RE: Springhill Suites by Marriott, 556 Main Street, Falmouth, MA

Horsley Witten Group, Inc (HW) has been retained by Mr. Gilbert Lavoie who lives nearby to the proposed project at 7 Morse Pond Road in Falmouth. Mr. Lavoie has expressed concerns about potential flooding of his basement due to high groundwater levels as a result of the proposed project and seeks to more fully understand the likely impacts of this project on his property and any possible remedies.

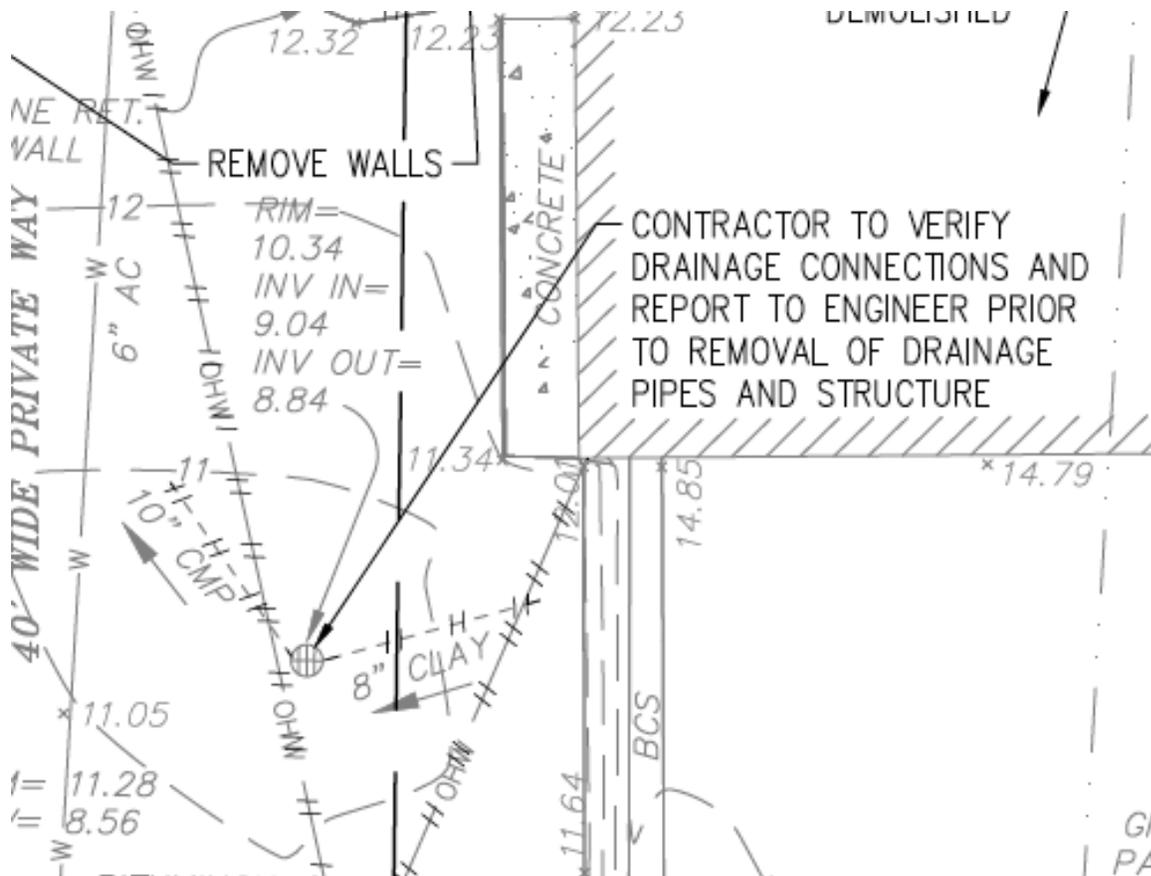
The proposed plan includes an extensive stormwater infiltration system to recharge virtually all of the stormwater runoff from rooftops, driveways and parking areas on-site. Plan C4 shows three areas identified as “R tanks” where stormwater infiltration is proposed (see excepted plan below).

The proposed stormwater infiltration structures are much closer to the northern property boundary than is the structure identified in the existing conditions plan. This suggests that groundwater mounding associated with the project may be increased at the abutting and nearby properties along the northern property boundary.

On behalf of our client, Mr. Gilbert Lavoie, we ask that the Commission request a hydrologic impact assessment of the proposed stormwater infiltration system before approving the project. Specifically we suggest that the applicant clarify the existing site conditions and stormwater routing and then conduct a groundwater mounding analysis of the proposed conditions. The

groundwater mounding analysis should evaluate both short term events (such as the 10-year and 100-year storms) as well as long term (steady state) conditions that will result from prolonged infiltration. Short and long term water table changes should be evaluated at the property boundary. In the event that this analysis suggests that the project will result in increased water table conditions at the surrounding properties we recommend that that the applicant evaluate the significance of groundwater mounding to neighboring properties as well as options to mitigate any significant impacts.
